ALLISON 05612 POWER TAKE-OFFS

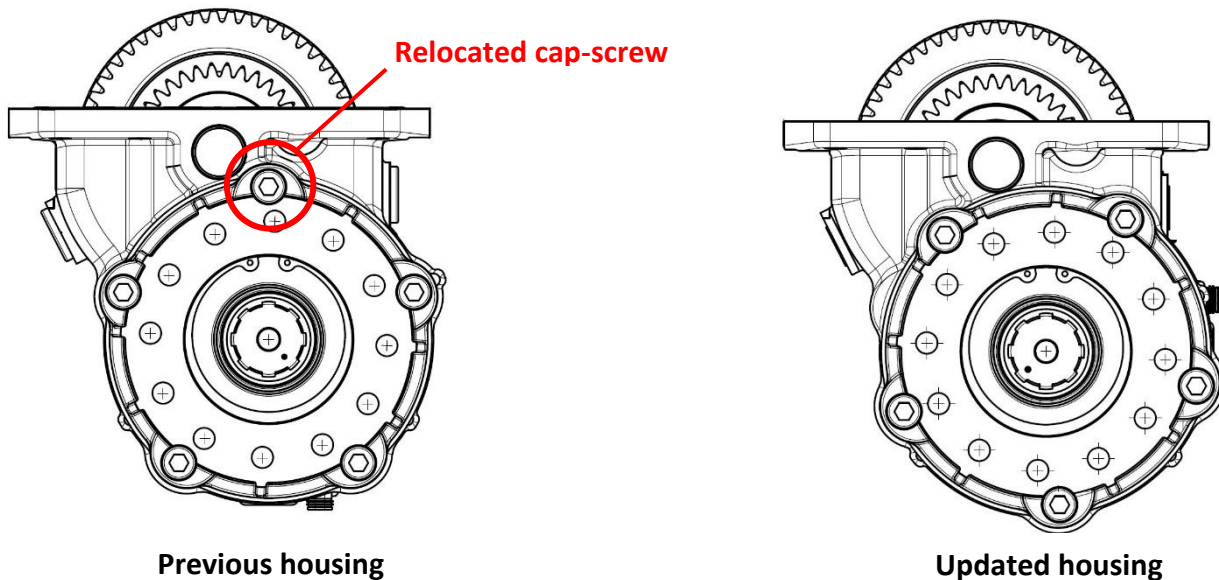
OMFB is pleased to advise of an update to Allison 05612* model power take-offs. Previously, the location of one of the output-flange cap-screws (as indicated below) caused fouling with the transmission in some instances. The output-flange of the PTO has been rotated to relocate cap-screws either side of the obstructed area. It is now possible to fit this version of housing to all Allison 3000 & 4000 Series side and top PTO openings.
